**REV2024/0020 (DA 2023/1469): Review of Determination of Application DA2023/1469 - Objection / Submission**

**REV2024/0020 (DA 2023/1469): Review of Determination of Application DA2023/1469 for alterations and additions to a dwelling housing including a swimming pool (955 Barrenjoey Road, Palm Beach)**

**Attachment 4:** Annotated plans (by Noble Planning July 2024) comparing the TSS and WSS surveys – suggesting significant anomalies between the two.

**Attachment 2:** Survey of 953 Barrenjoey Road by Waterview Surveying Services, dated 30/11/2021

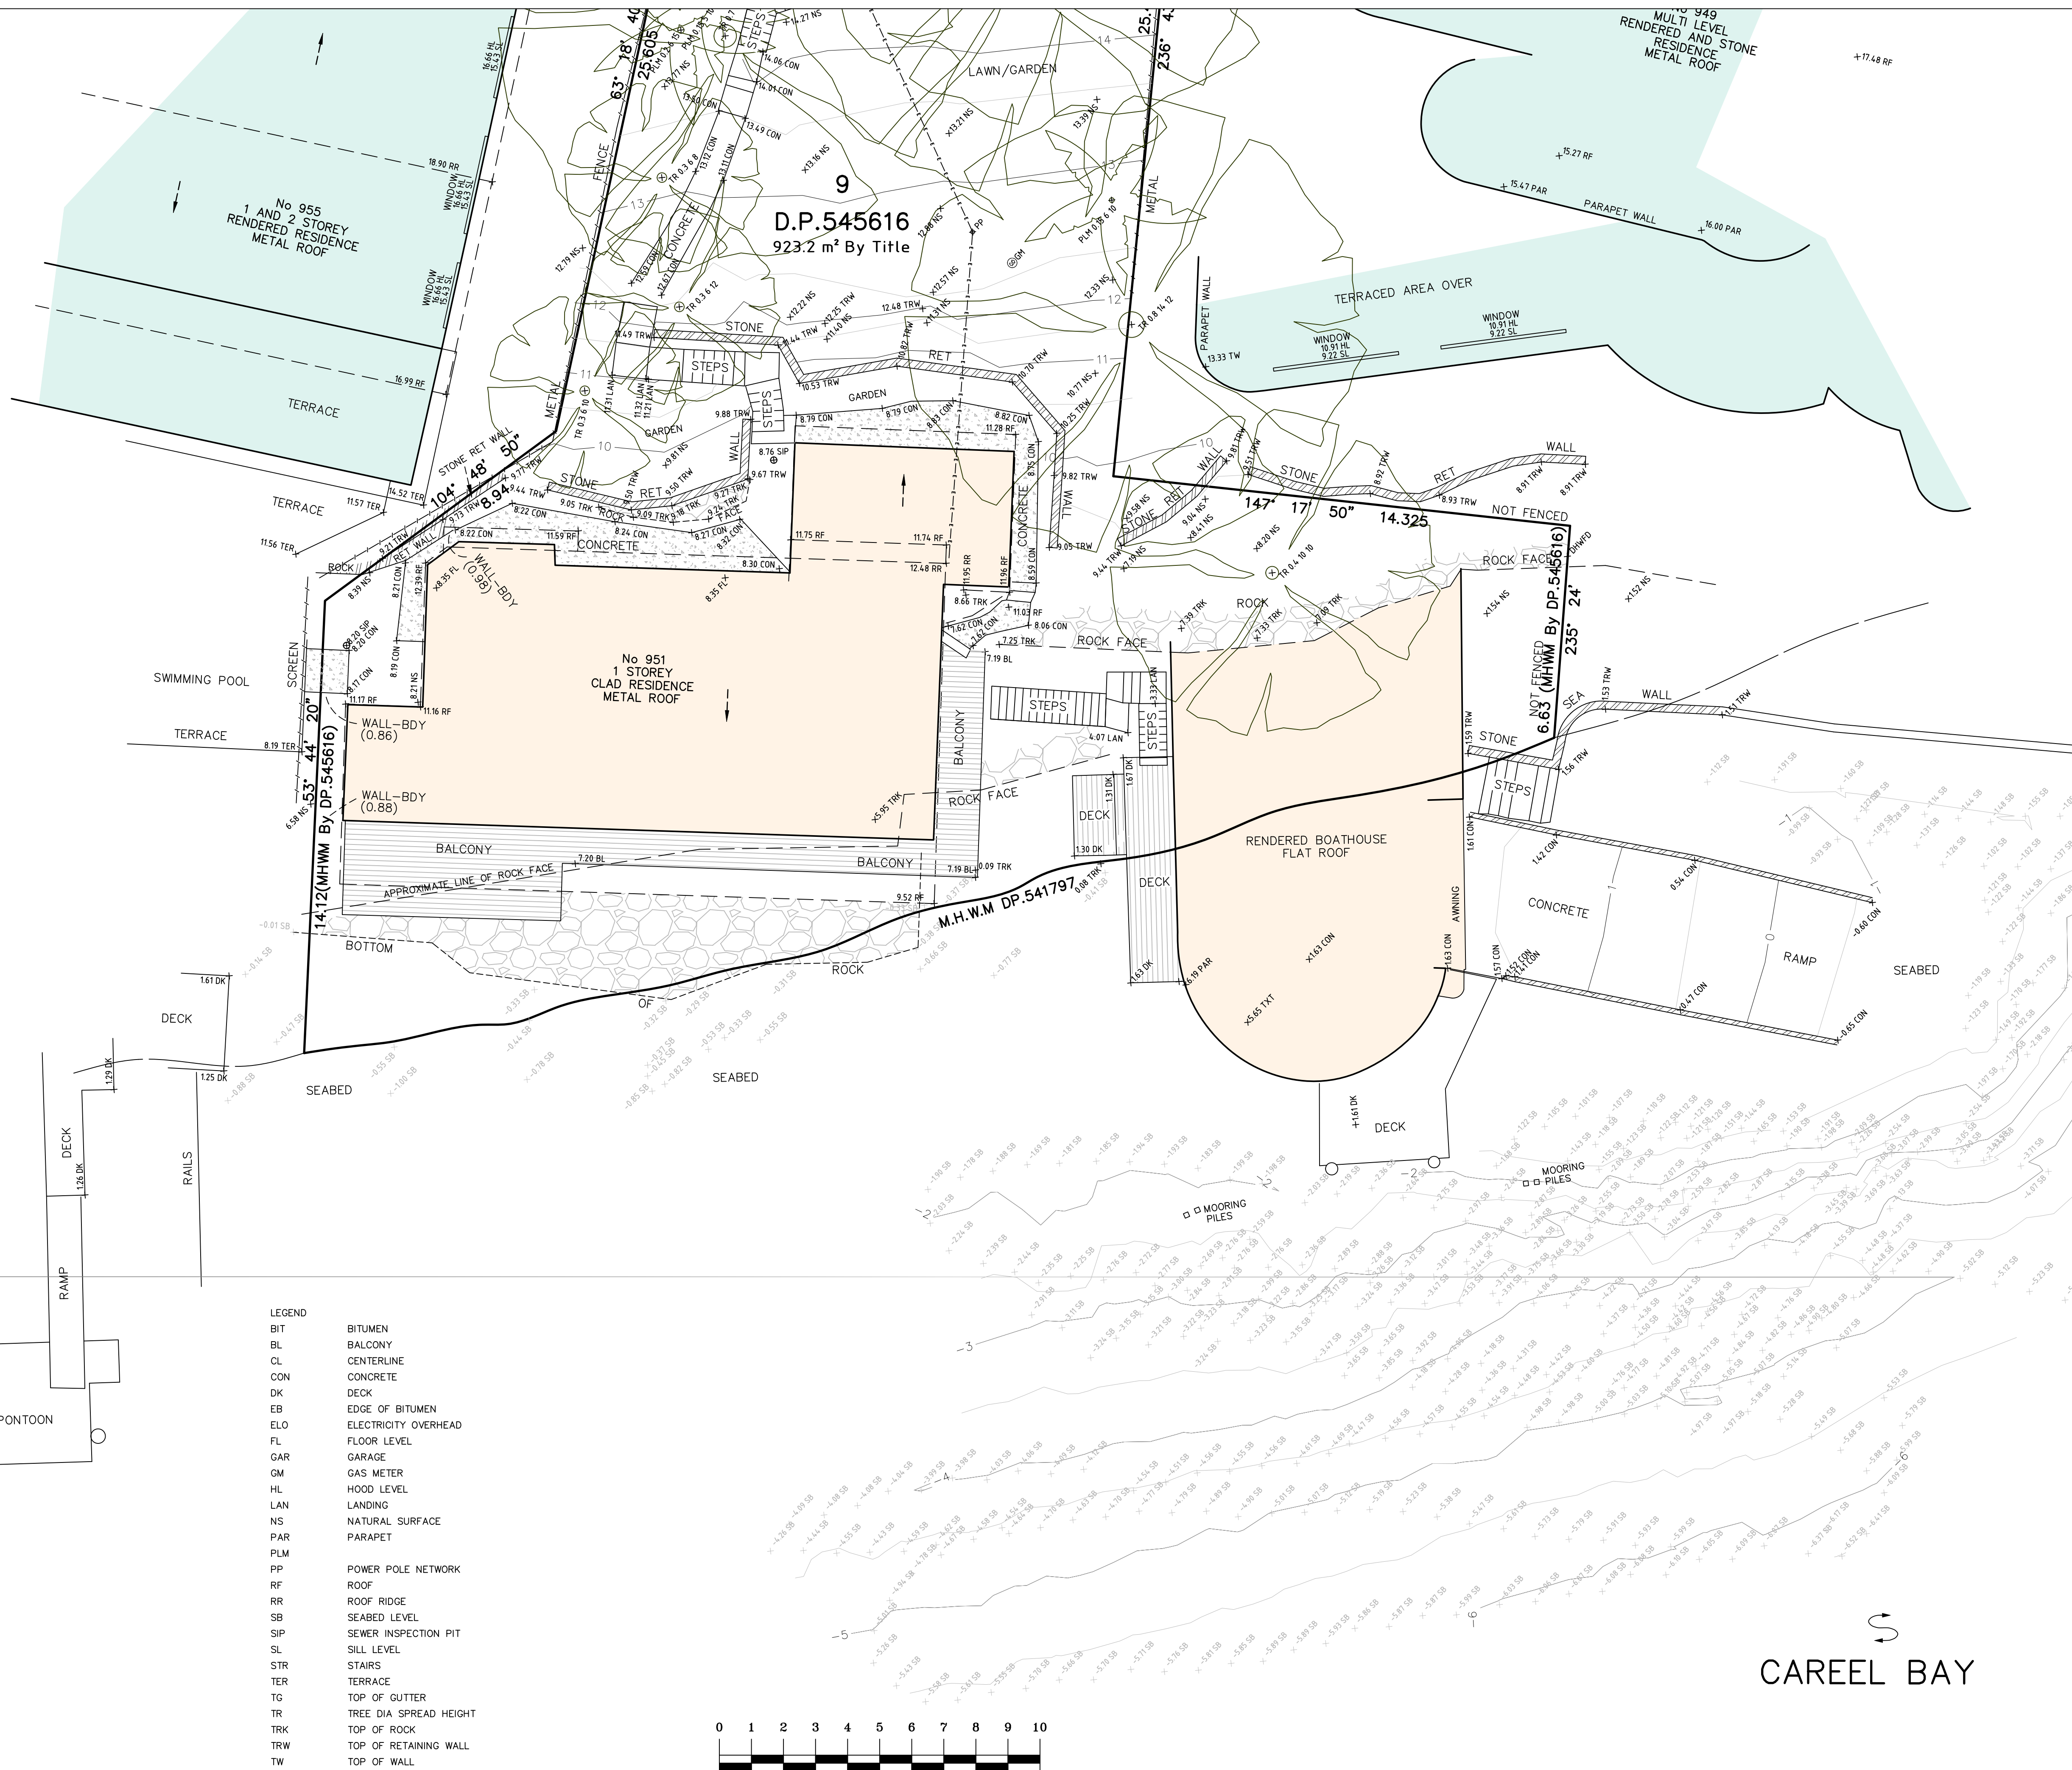
A copy of the survey undertaken for the Riggalls by Waterview Surveying Services can be found at [Attachment 2](#)

The surveyor (Michael Joyce) who undertook the survey for the Riggalls has confirmed that their survey was based on existing survey markers located on-site, as shown on the marked-up Deposited Plan 545616 (the Title Diagram). Refer [Attachment 3](#).

Comparison of boundary alignment between House (at 953 Barrenjoey Rd) and Pool Fence (at 955 Barrenjoey Rd)

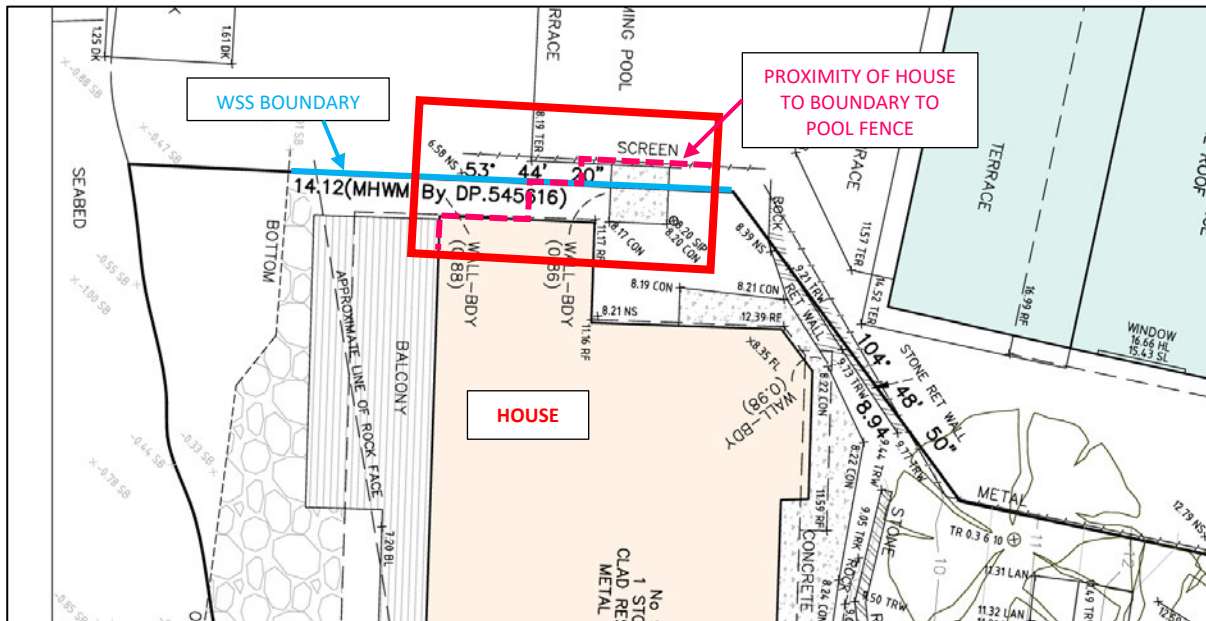
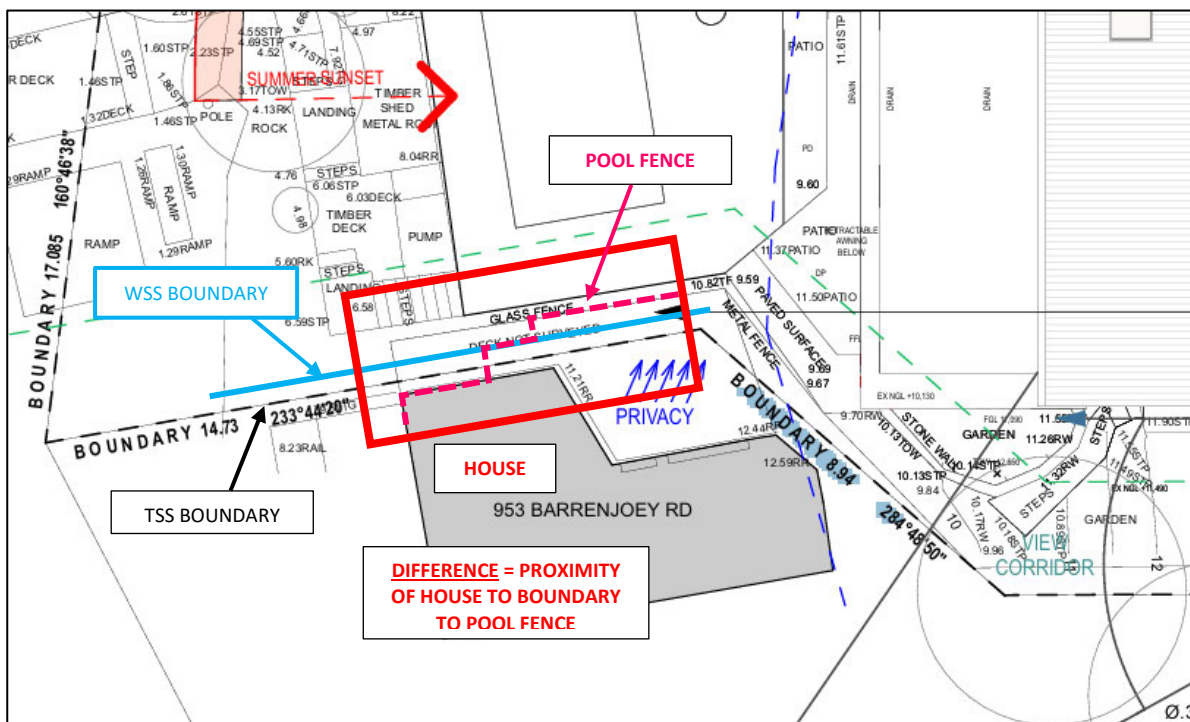
The level of error between the two boundaries appears to be **between 0.5 – 0.75 metres** – resulting in a potential total impact of up to approximately **34 sqm** of land. Whilst acknowledging the differences between the two plans of survey could simply be the result of “*human error*”, the resulting impact on the ground is **very significant**, with major implications for the two property owners.

Comparison of boundary alignment between House (at 953 Barrenjoey Rd) and Pool Fence (at 955 Barrenjoey Rd) – ASSUMING SAME DIMENSIONS

1. make the applicant (and their surveyor) aware of this issue **as a matter of urgency**;
2. require the applicant (and their surveyor) to **double check** their survey data;
3. require the applicant (and their surveyor) and provide a “**confirmation**” **survey**, with reference to the existing survey markers located on-site (as identified in **Attachment 3**) .

Comparison of boundary alignment between House (roof width / ridge at 955 Barrenjoey Rd) and Fence and Trees (at 953 Barrenjoey Rd)

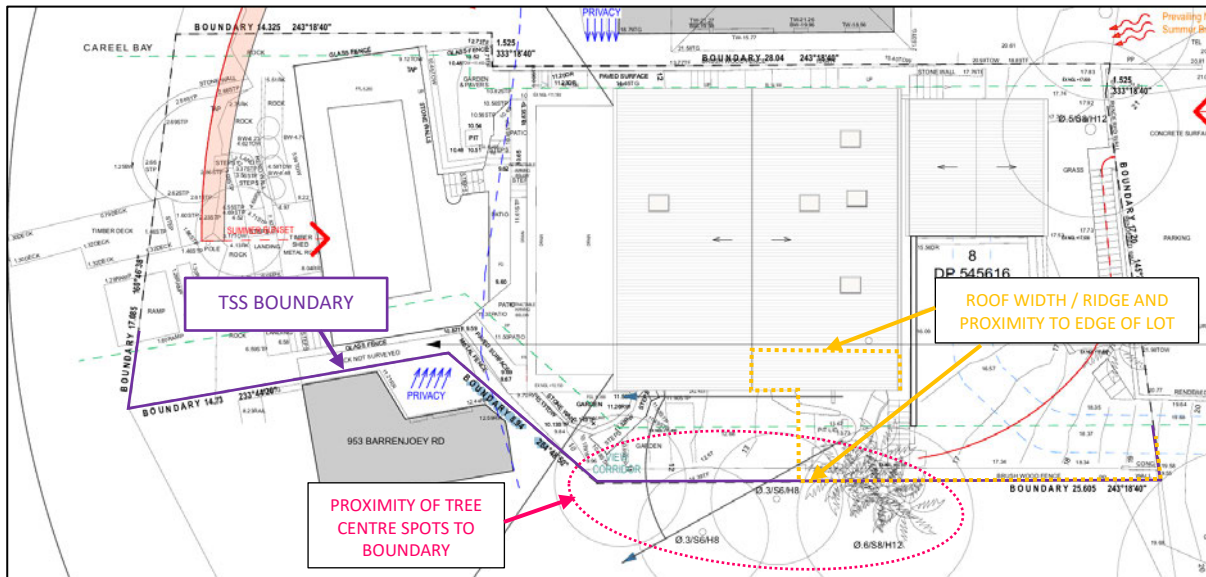
Comparison of boundary alignment between House (roof width / ridge at 955 Barrenjoey Rd) and Fence and Trees (at 953 Barrenjoey Rd)
